W3F1-98-0120  
A4.05  
PR

Subject: Waterford 3 SES  
Docket No. 50-382  
License No. NPF-38  
Requests Associated with  
ASME Section XI, Table IWB-2500-1,  
Examination Category B-A, Item B1.10 and B1.30,  
Reactor Vessel Shell and Shell-to-Flange Welds

**REQUESTS ISI-018 and ISI-019**

REQUESTS ISI-020

Vessel-to-Flange

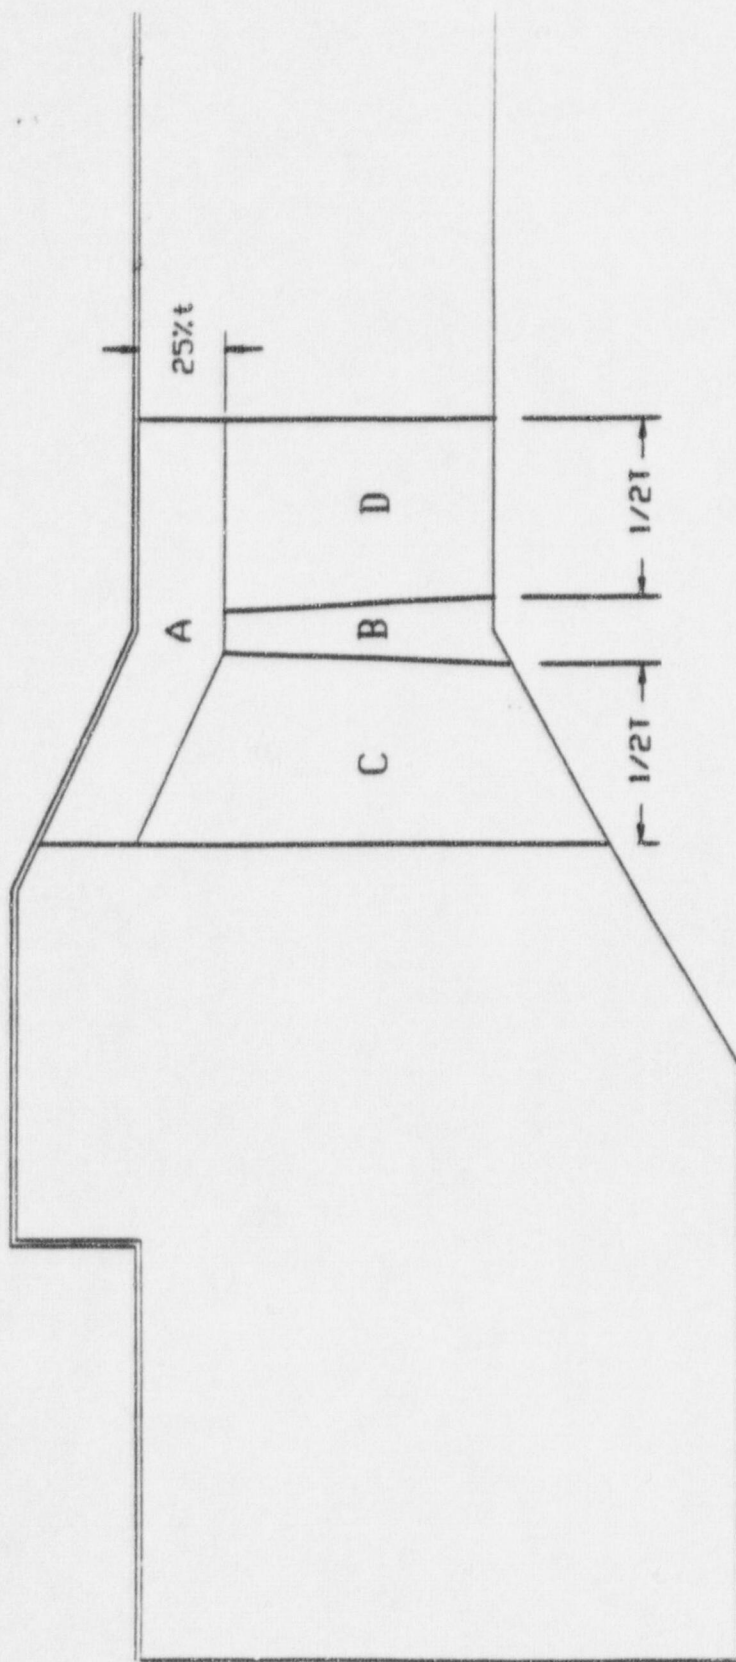
Component ID	Component Description	Item No	Limited Exam	Limitation
01-020	RPV UPPER SHELL-TO FLANGE WELD	B1.30	79%	EXAM LIMITED DUE TO SURFACE TAPER

The design configuration of the flange precludes full ultrasonic examination of the RPV Upper Shell-to-Flange Weld, 01-020. The weld volume was examined from the vessel wall and the flange face using 5 different transducers. However due to the taper of the flange (See Page 2) the transverse scans were limited in Volume "A" to 48% and Volumes "B", "C", and "D" to 54%, limiting total examination coverage to 79%. In order to examine the weld in accordance with the Code requirement, the reactor vessel would require extensive design modifications. Consequently, the design restriction makes the Code-required examination impractical. Waterford believes that the significant coverage obtained would have detected any generic degradation, if present, and therefore provides reasonable assurance of structural integrity.

Pursuant to 10CFR50.55a(g)(6)(i), EOI requests relief from the Code-required essentially 100% volumetric examination of reactor vessel shell-to-flange weld.
